Introduction

A review of the "Hydrometry Report" and the "Allt Chaorainn Eia Report Volume 1" submitted to the planning portal on the 4th of July 2018 has been carried out and an analysis of the impact the scheme would have on the number of days a year the river would be navigable. In addition, the increase in risk to paddlers as a result of the steepening of the hydrograph rising limb at low flows is discussed.

Figure 1: Analysis of change in exceedance flows.

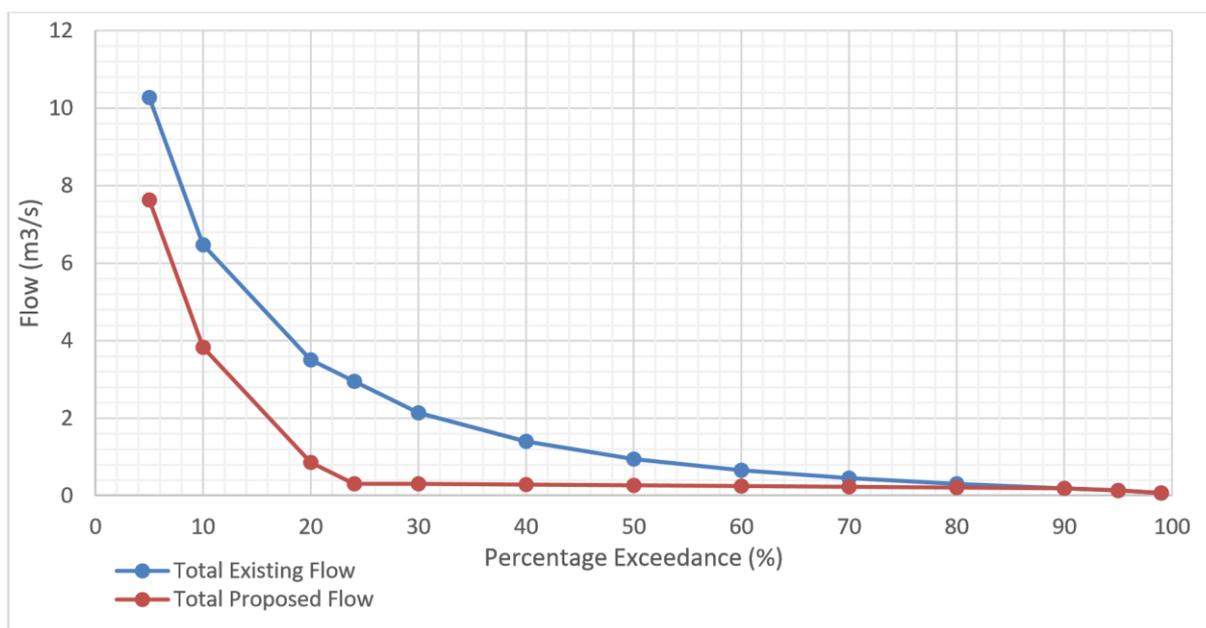
Table 1 and Figure 1 below show how the exceedance flows in the watercourse will be affected by the abstraction based on the above assumptions.

These flows and the number of days where the flow exceeds each given flow have been used to derive the number of days where the river is navigable. Linear interpolation between the data points has been used to bridge the variation between each data point.

In the existing case the number of days a year where the flow is between $0.5\text{m}^3/\text{s}$ and $4.0\text{m}^3/\text{s}$ is 180.8 days.

In the proposed case the number of days a year where the flow is between $0.5\text{m}^3/\text{s}$ and $4.0\text{m}^3/\text{s}$ is 61.3 days.

The number of days the river will in theory be navigable in the proposed case is approximately a third of the days it is navigable in the existing case.

Figure 2: Illustration of scenario in relation to realistic hydrograph

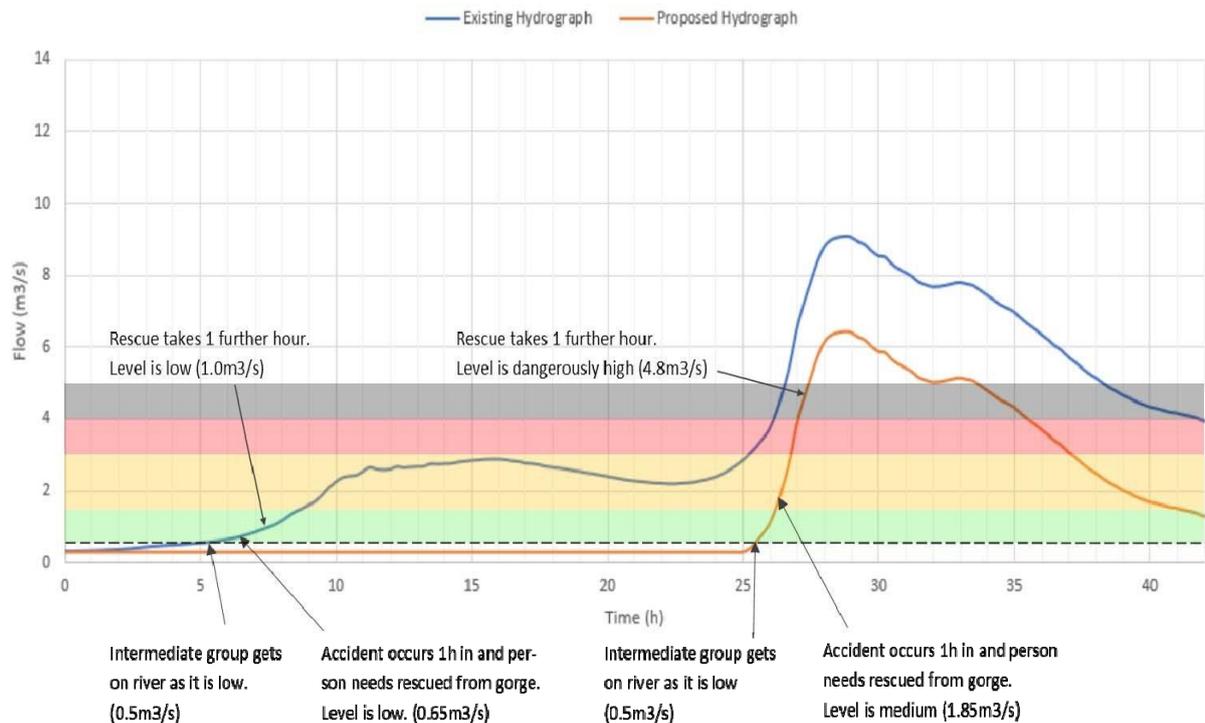
As illustrated in Figure 2 in the existing case the group got on the river when it was low ($0.5\text{m}^3/\text{s}$). As in the proposed condition it is not possible for them to get on the river as the compensation flow is too little for them to paddle they got on when the flow reaches a sufficient flow for them to paddle it.

In the existing case by the time the accident happened the flow had only increased to $0.65\text{m}^3/\text{s}$ (still low) as they are in a slowly rising portion of the hydrograph. In the proposed case the level at the time of the accident is $1.85\text{m}^3/\text{s}$ (medium) as they are in a more rapidly rising portion of the hydrograph.

By the time the mountain rescue arrive and are in a position to rescue the injured paddler, in the existing case the level is still low ($1.0\text{m}^3/\text{s}$) where as in the proposed case the level has risen to $4.8\text{m}^3/\text{s}$ and is now far higher than the most experienced kayakers would consider navigating it and as a result the paddler (unable to exit the gorge in the state they are in) may be swept downstream with potentially fatal consequences.

There is therefore clearly an increase in risk to the kayakers as a result of the proposed scheme and this does not even take into account the potential for emergency shutdowns of the turbine causing a rapid increase of up to $2.644\text{m}^3/\text{s}$ within seconds or minutes which could cause a fun day out to become a serious accident.
